AGENDA ITEM SUMMARY REPORT

APPLICATION NO.: Use Permit 2-23 (UP 2-23), Design Review 3-23 (DR 3-23); [Variance \(VAR 2-24\)](#) Sign Permit 8-23 (SP 8-23)

PROJECT: Consideration of Use Permit 2-23, Design Review 3-23, Sign Permit 8-23 and [Variance \(VAR 2-24\)](#) applications requesting to convert an existing commercial building to the following uses: Restaurant with arcade, General Retail, and four Multi-Family Dwelling Units in the inland Central Business District. [The project includes an extensive interior remodel for the conversion of an office building into the aforementioned uses. It also includes the removal of the outdoor teller shelter on the north side of the building, the drive-through structure on the east of the building and installation of a number of windows and doors. The project includes the following associated development: new landscaping, pedestrian walkways, signage, fencing, bicycle parking, dumpster shelter, exterior lighting and mechanical equipment.](#)

LOCATION: 228 N. Main Street (APN 018-153-28)

Figure 1. West Elevations - Before (top) and After (bottom)

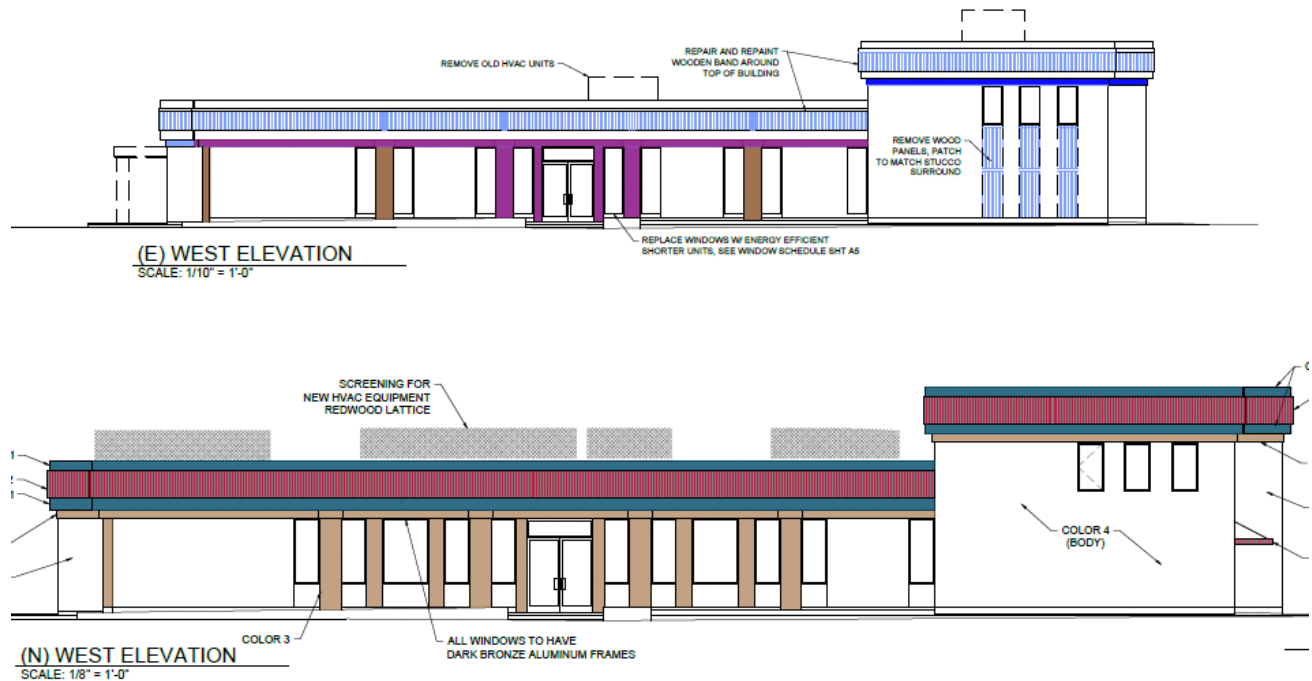
2. Resubmit the building elevations with additional decorative details, some suggestions included:
 - Use a three-color paint scheme, as the commissioners expressed interest in painting the parapet a different color, repainting on a band on the building in a different color, painting around the window alcoves and/or painting newly installed window trim. The Commission expressed interest in seeing details or an exterior painting plan that would give the building more definition and articulation. MJC suggested that the applicant consider painting the two-story structure a different color than the restaurant side, so that the building has two distinct masses.

- Consider adding window trim or some other architectural detail to the exterior.
3. Prepare a Variance analysis for the project to determine if the site/project would meet the requirements for a variance. The variance would be to eliminate the requirement for a loading zone and associated masonry wall. Commissioners noted that other businesses of similar size in downtown do not have loading zones and that the geometry of the loading zone area would make truck access and use difficult.
